MTA Construction & Development

This is in response to NYCDCP's November 6, 2024 polling letter to MTA C&D/ Bridges & Tunnels (on behalf of TBTA) requesting our comments on ULURP application No. 250085 MMX with responses due by December 9, 2024. The following are our comments in this regard.

Project
BALLY'S NEW YORK FERRY POINT
BRONX COUNTY NEW YORK

## CONCEPTUAL SITE PLAN

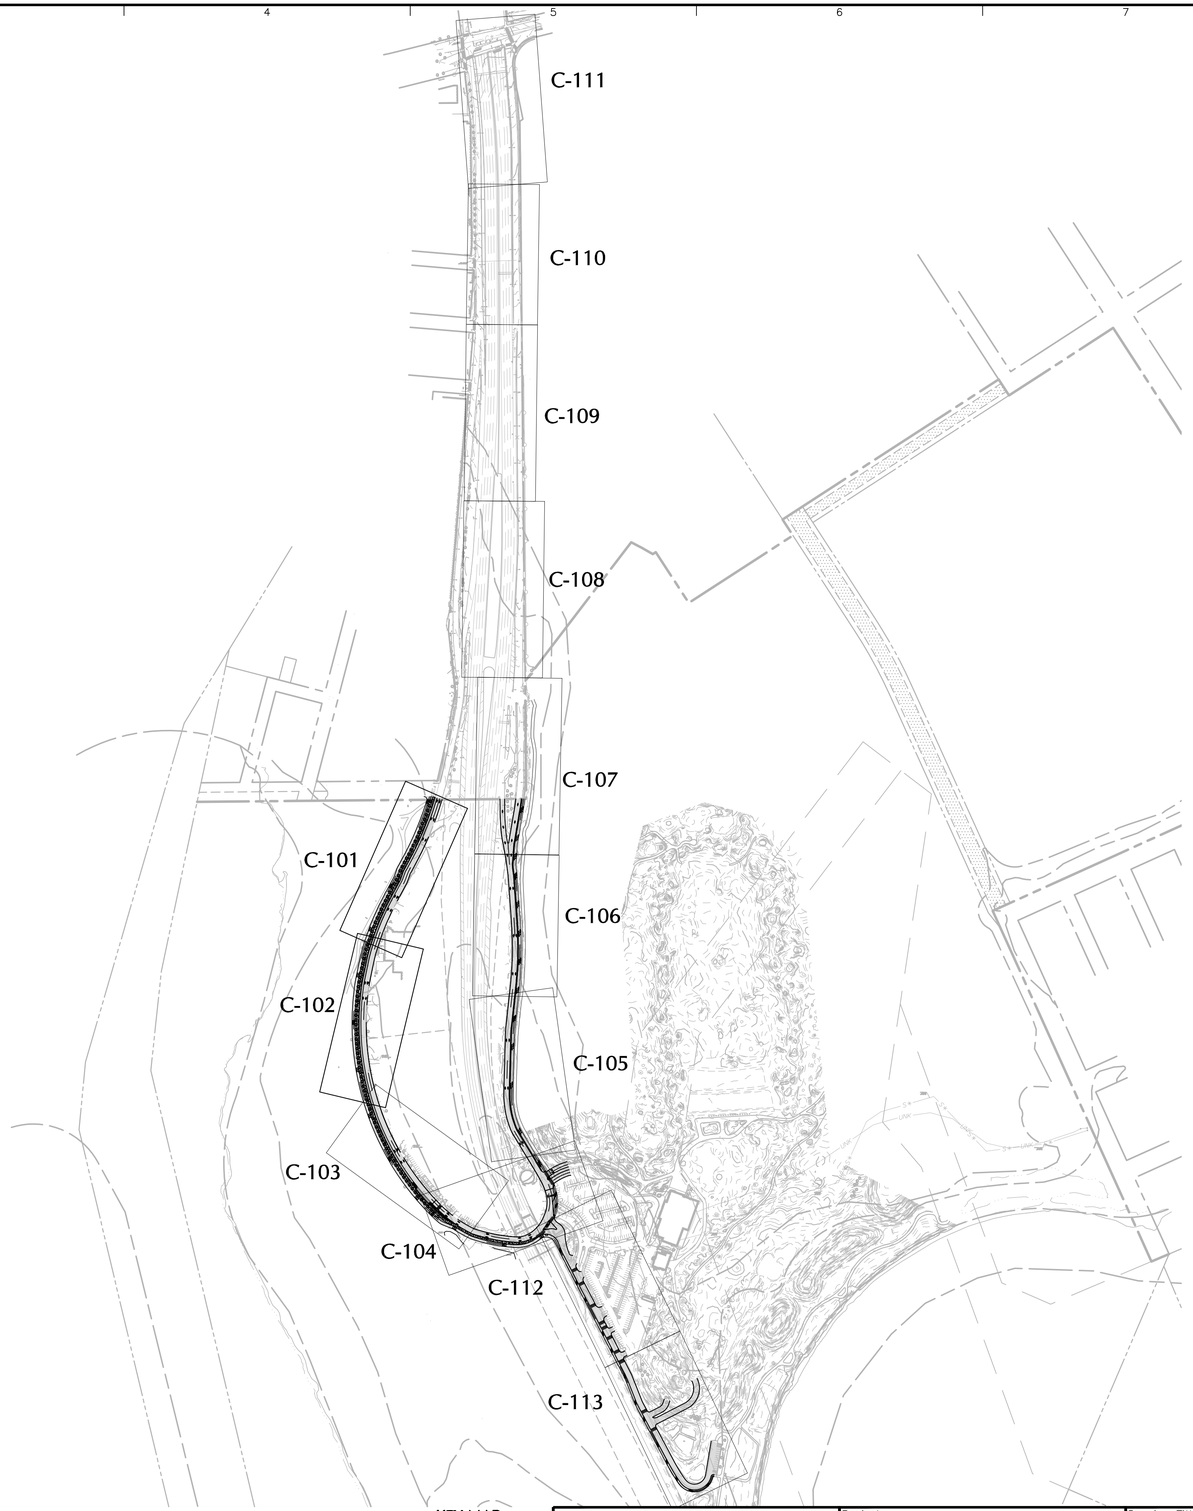
- C-104- Can the sidewalk and bike lane be combined as a shared use path earlier than shown?

| Project | Drawing Title | Project No. | Drawing No. |
|---|---|---|---|
| BALLY'S NEW YORK FERRY POINT<br>BRONX COUNTY NEW YORK | CONCEPTUAL SITE PLAN | 170773001<br>Date 10/22/2024<br>Drawn By JP<br>Checked By MH | C-101<br>Sheet 2 of 14 |

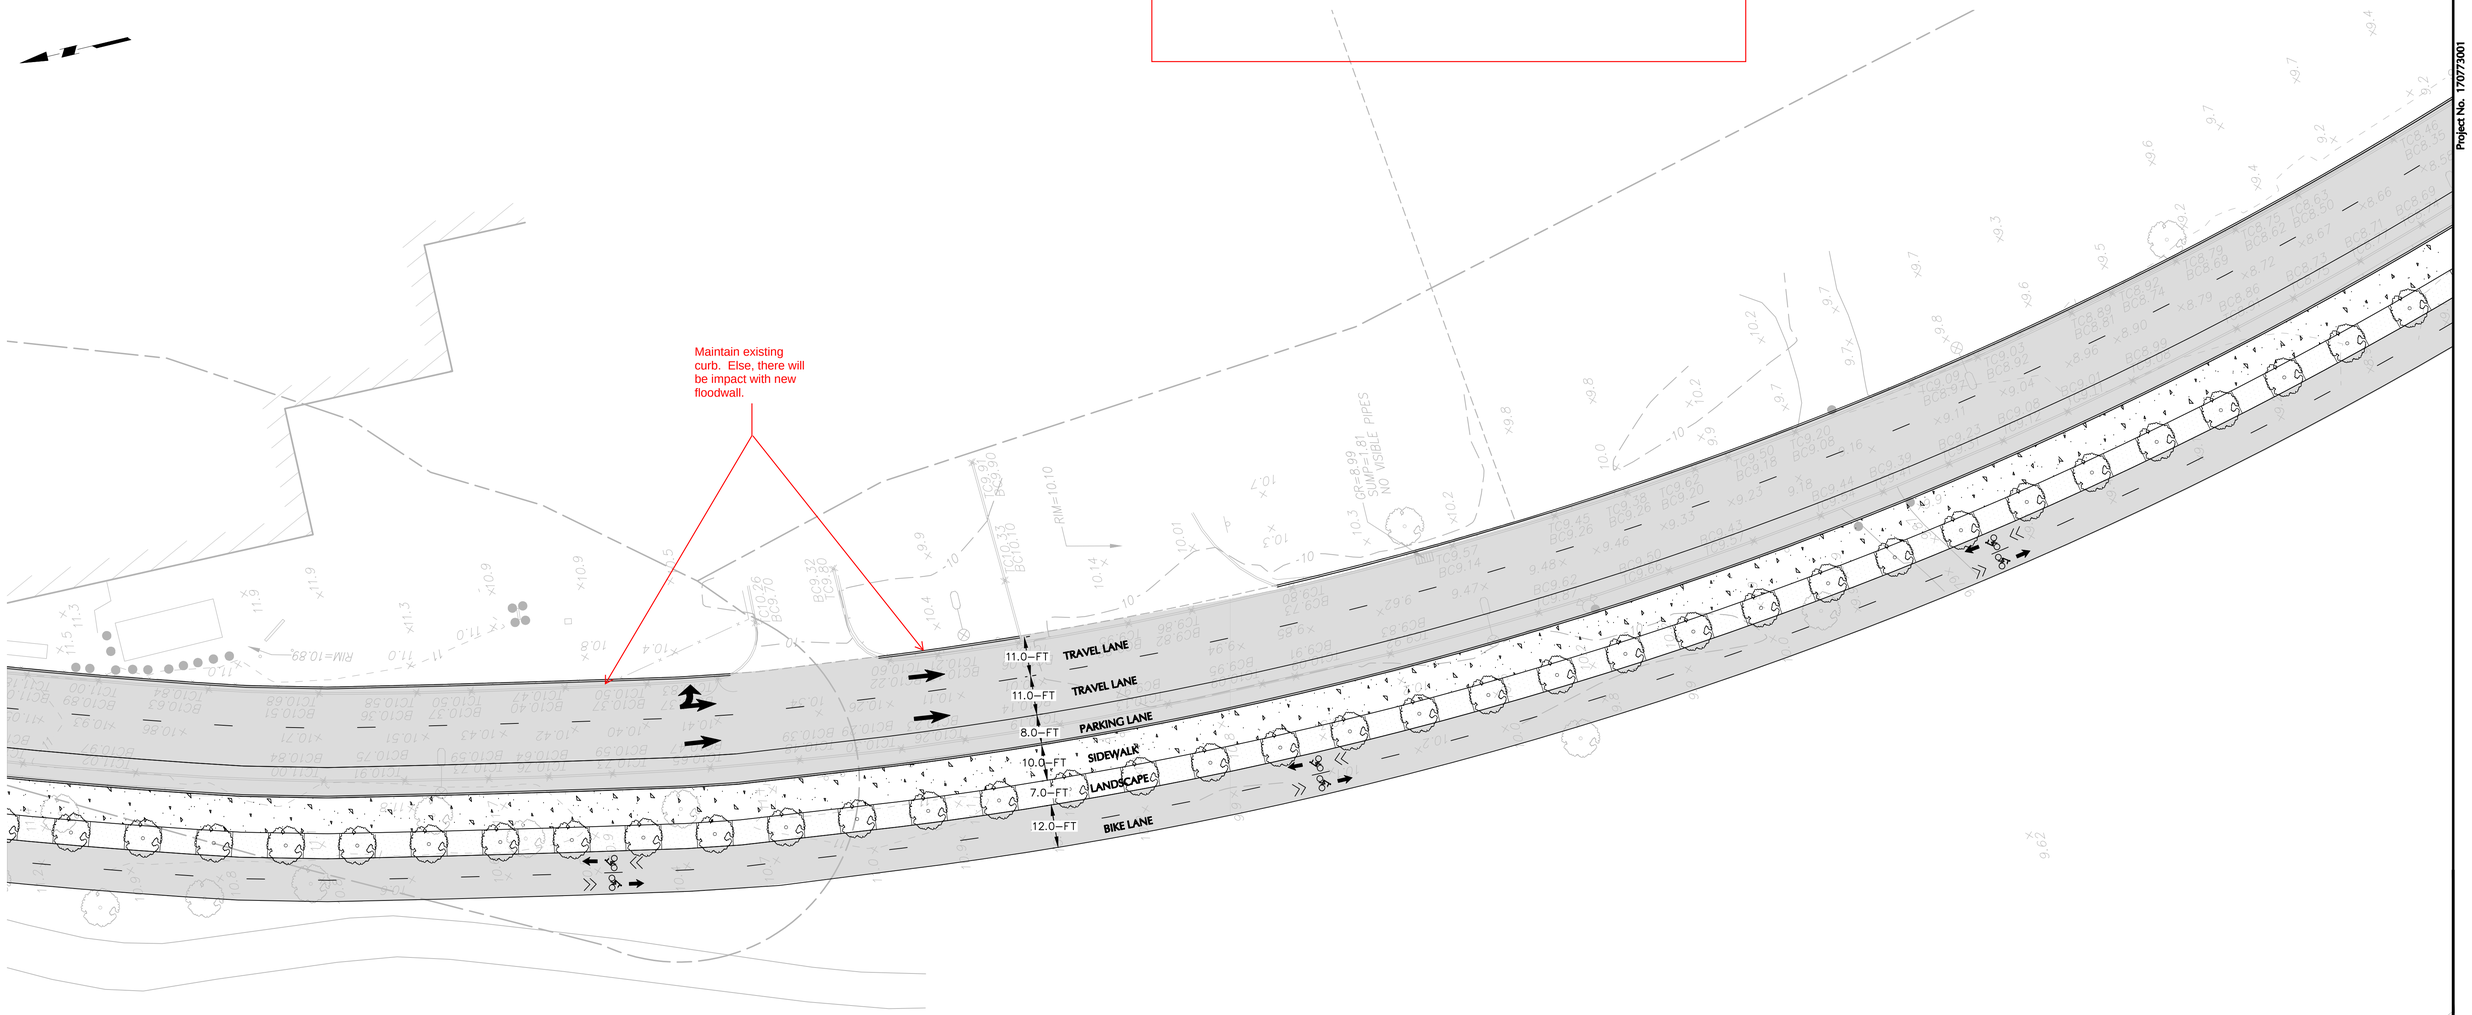
- C-101- The crossing at Schley Ave is signed to Stop. Will it remain signed to Stop?
    - C-101- The utility pole on the west side of Ring Road supports telephone service to TBTA's service building. The service wires must be relocated.

- C-101- Due to the road widening, lightpoles on the westerly side will be removed. Please provide a lighting plan with new lightpole locations.
    - C-101- Why is there a kink in the road near the entrance to TBTA's parking lot? It makes more sense to have the road go straight through and just provide a widened area on the westerly side with a turning lane into TBTA's parking area. Also, TBTA has a guide rail in front of the fence in this area which needs to be maintained. In addition, there is a MH on the NE corner of the entrance that must be protected.

-Protect existing TBTA improvements along east edge of road, i.e., floodwall

This utility pole supports telephone service to the service building. Service wires have to be relocated.

Is existing curbline being maintained on the east side of Road?

Authority's utility feed goes across loop road from this manhole. Be careful of any trenching work.

Lightpoles are to be removed. Show new lighting plan. (TYP)

Why make a kink in the new road?

Crossing at Schley Avenue is currently signed to stop. Is that to remain?

| Drawing No. | C-105 |

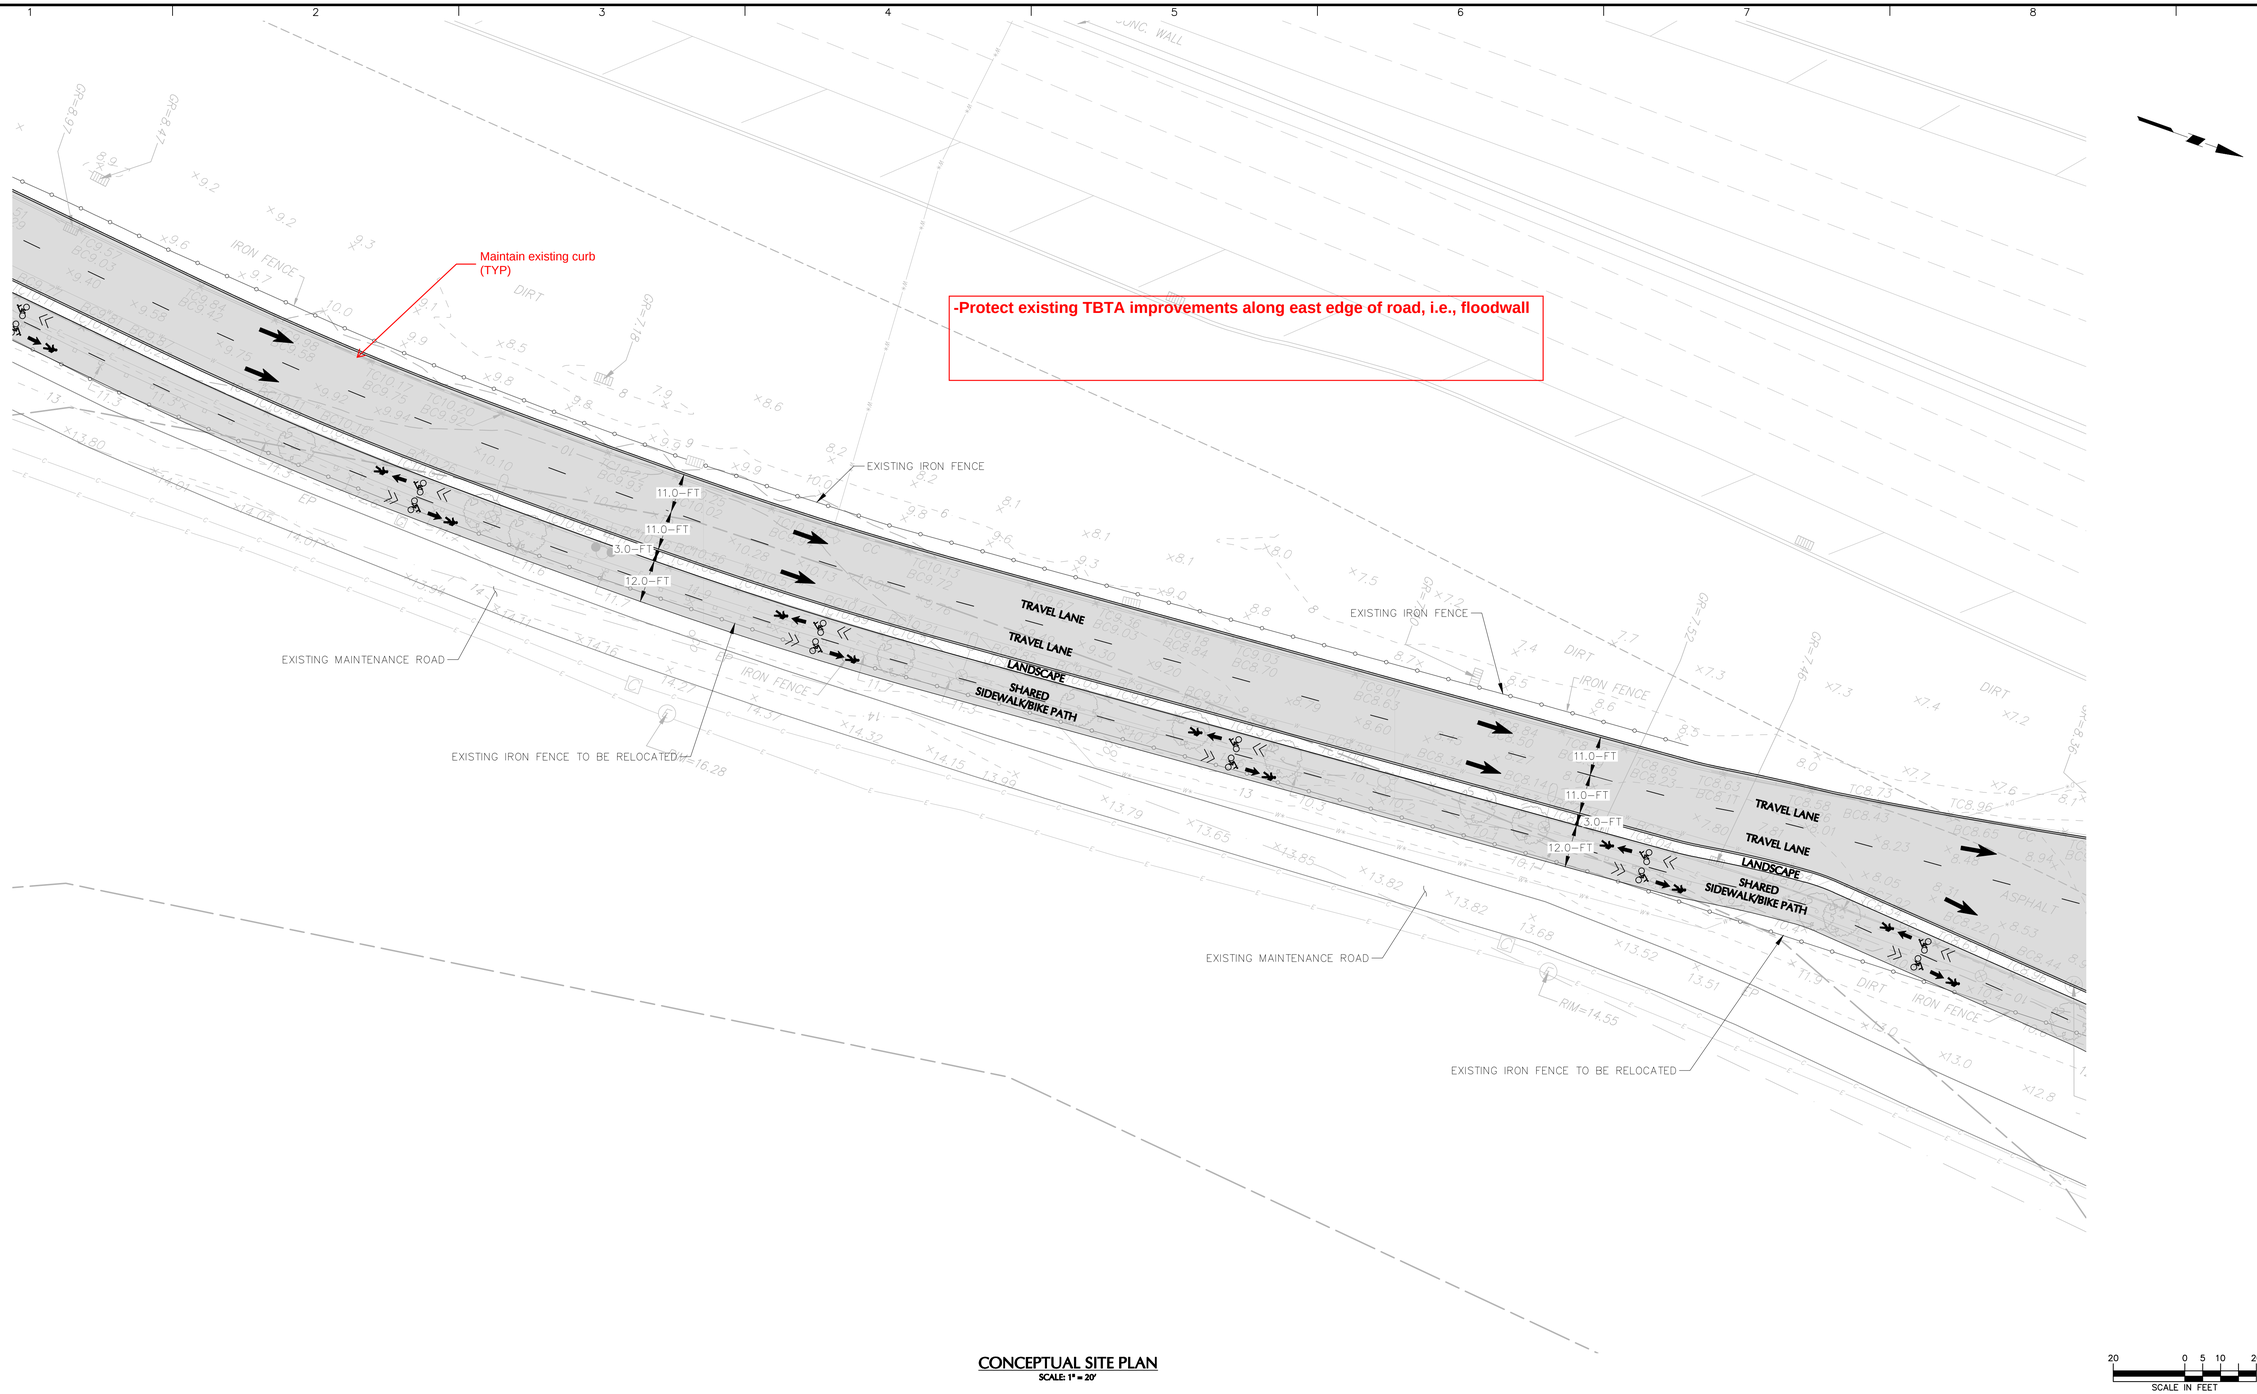
- C-105- The agreement in the field was to maintain the existing curbline and guide rail along TBTA's fence line (typ.)
- C-105- Must allow for curb cut and access to existing gate.

Agreement in the field was to maintain existing curb line and guide rail along TBTA fence line. (TYP)

Allow for curb cut and access to existing gate.

| Drawing No. | C-112 |

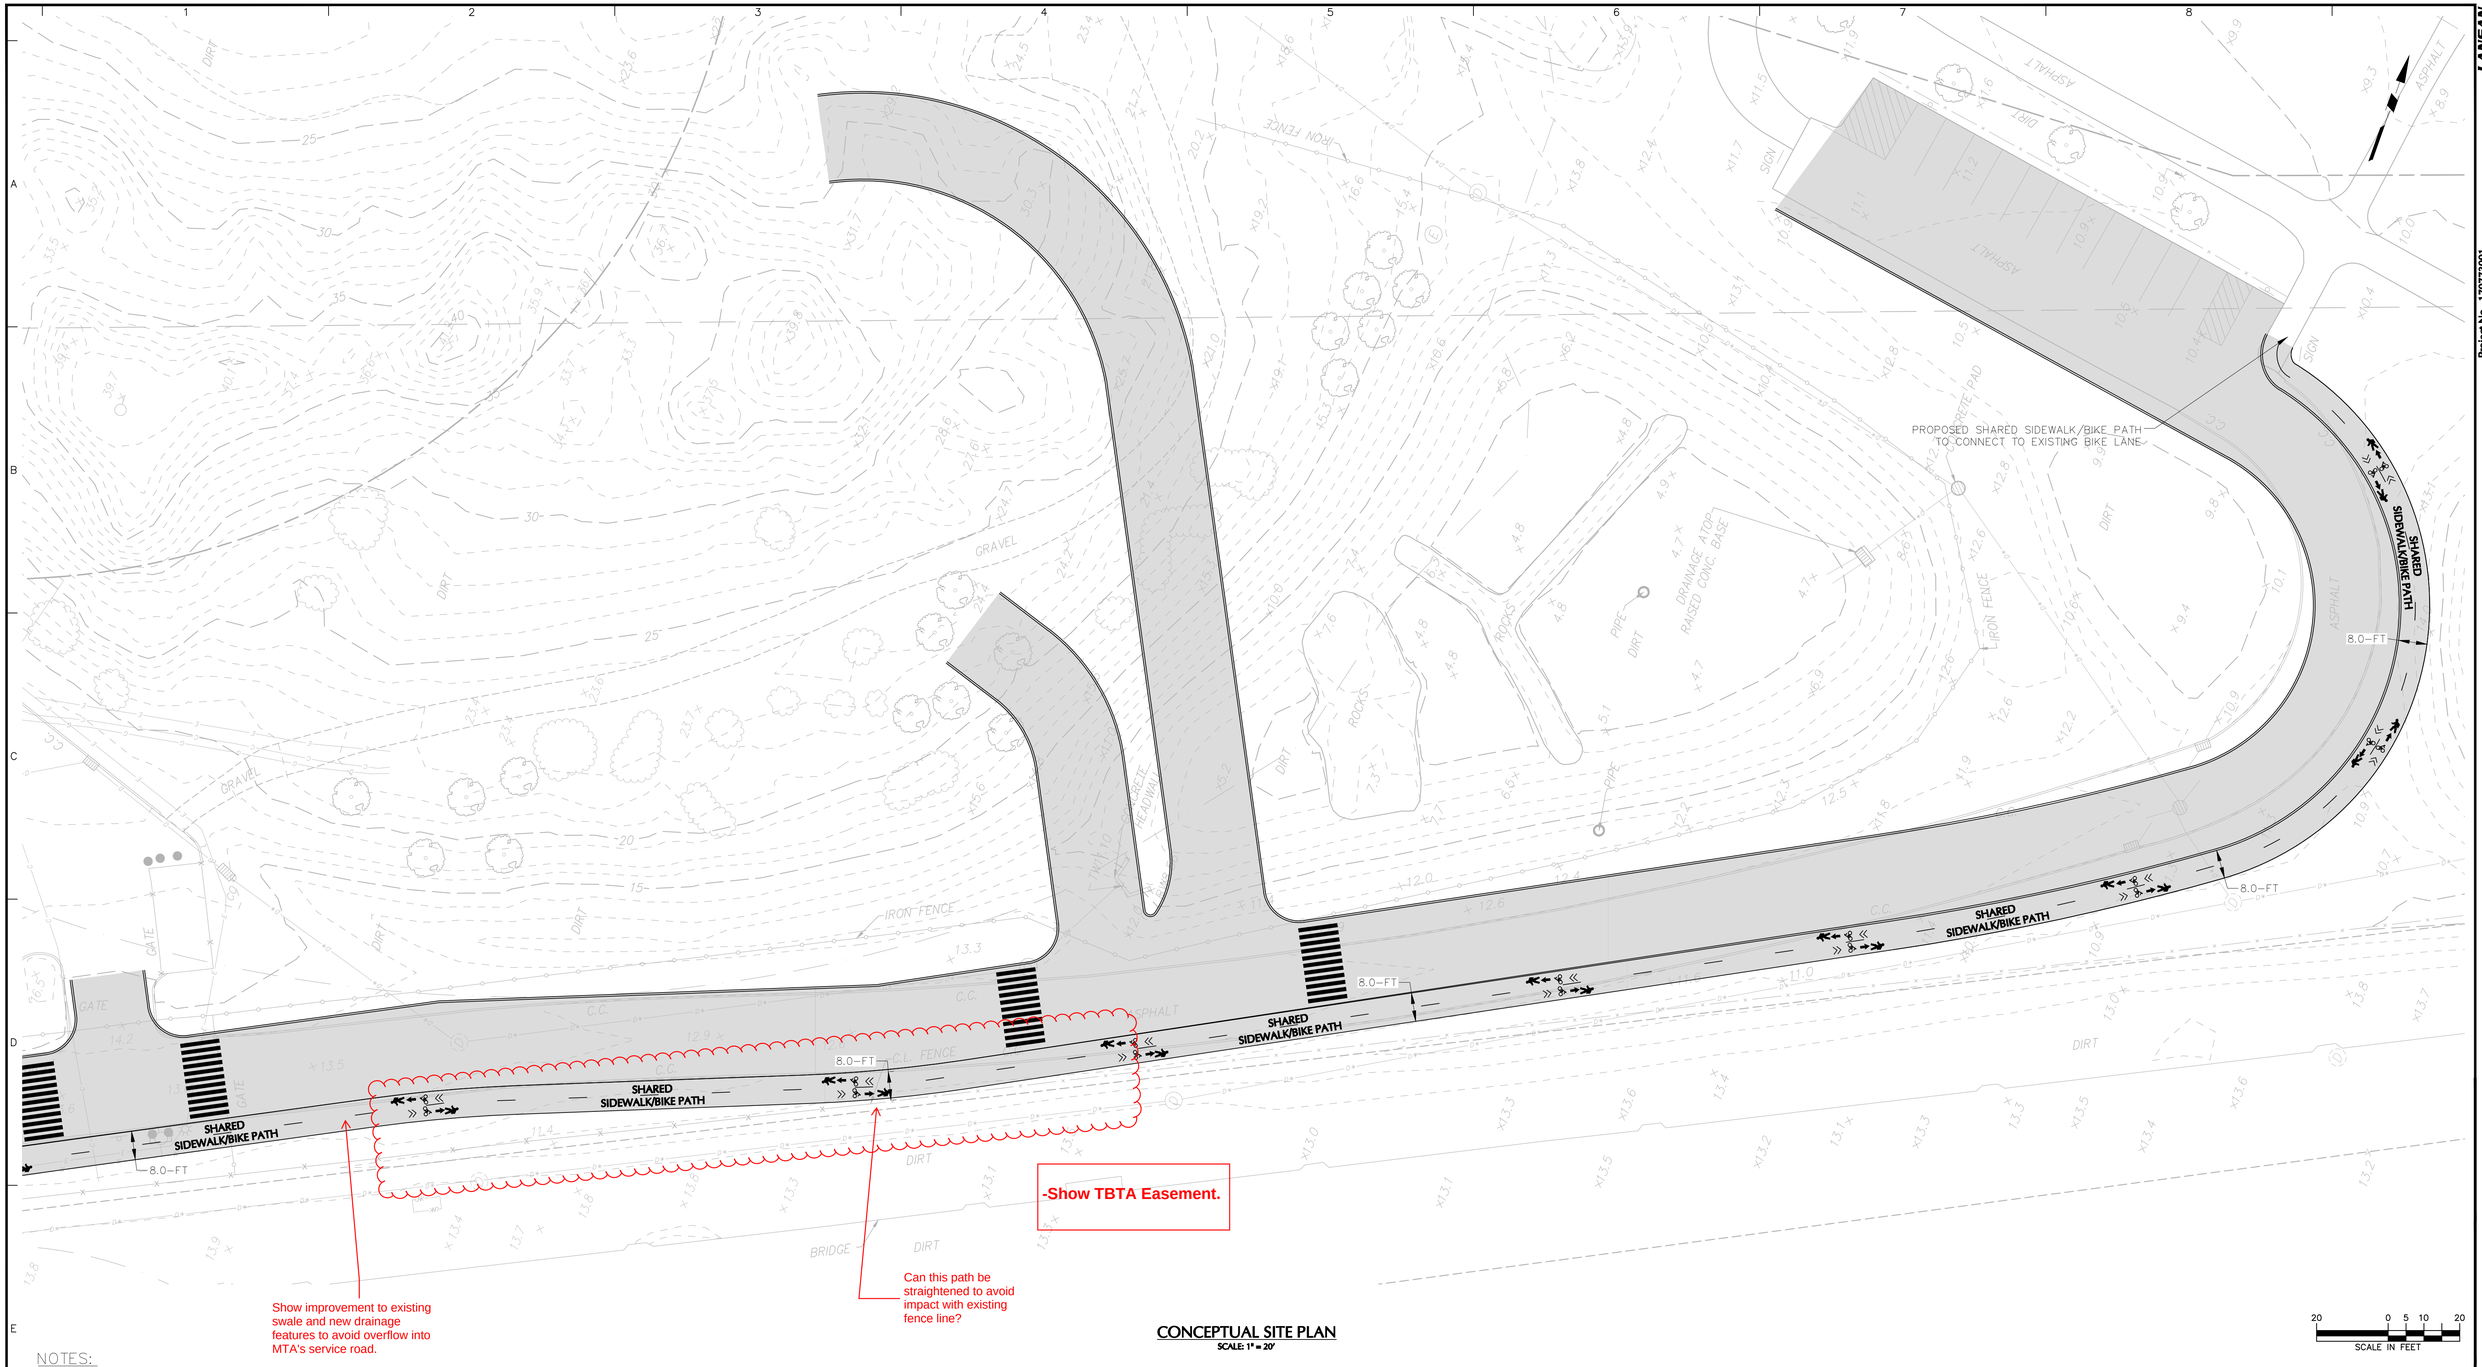
- TBTA's fence line on Conceptual Site Plan C-112 and C-113 is shown to conflict with the SUP. Per email correspondence on 11/21/24, the applicant's team is checking this issue. This could affect the parkland elimination map.

- C-104, C-112 and C-113- What will happen to the existing swale at the SW end of Ring Road and along TBTA's fence line which controls stormwater and runoff. With the swale gone what drainage improvements will be made that can handle the addition of new impervious surfaces and prevent overflow into MTA's service road?

Existing fence line is impacted. Relocate shared use path line.

Show improvement to existing swale and new drainage features to avoid overflow into MTA's service road.

-Show TBTA Easement
